SUBJECT: EPRI Topical Report TR-112657 Revision B-A, Revised Risk-Informed Inservice Inspection Procedure. Reference Project #669.

TR-112657 Rev. B-A

**SAFETY EVALUATION REPORT RELATED TO
"REVISED RISK-INFORMED INSERVICE INSPECTION EVALUATION PROCEDURE"
(EPRI TR-112657, Rev. B, JULY 1999)**

Figure 3-6
Decision Criteria for Evaluating RI-ISI Impacts on CDF and LERF

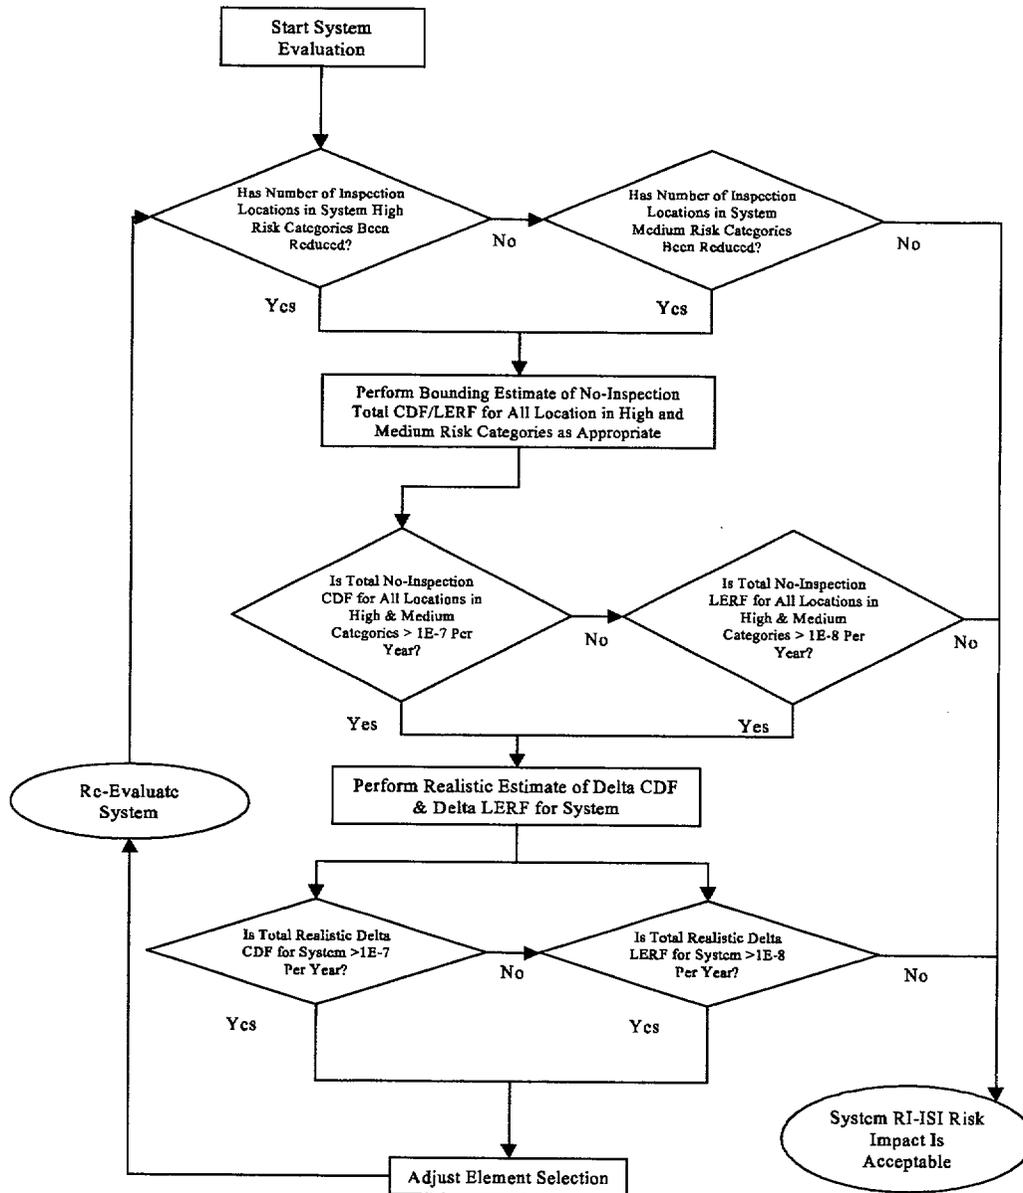
For more extensive changes in the number of inspections in the High- and Medium-risk category welds, a quantitative estimate of the change in risk should be developed. The EPRI TR includes a flowchart in Figure 3-6 that outlines the decision criteria for evaluating RI-ISI impacts on CDF and LERF. The staff finds that this flowchart contains the appropriate steps in the correct sequence to guide the estimation of risk process and to determine what level of effort is required on the basis of the specific results of each licensee's evaluation. The bounding calculation methodology using both no POD increase and a POD increase was reviewed by the staff during the pilot applications and found to be acceptable for investigating the change in risk associated with changing the number and the locations of welds to be inspected as part of an RI-ISI application that uses the EPRI methodology.
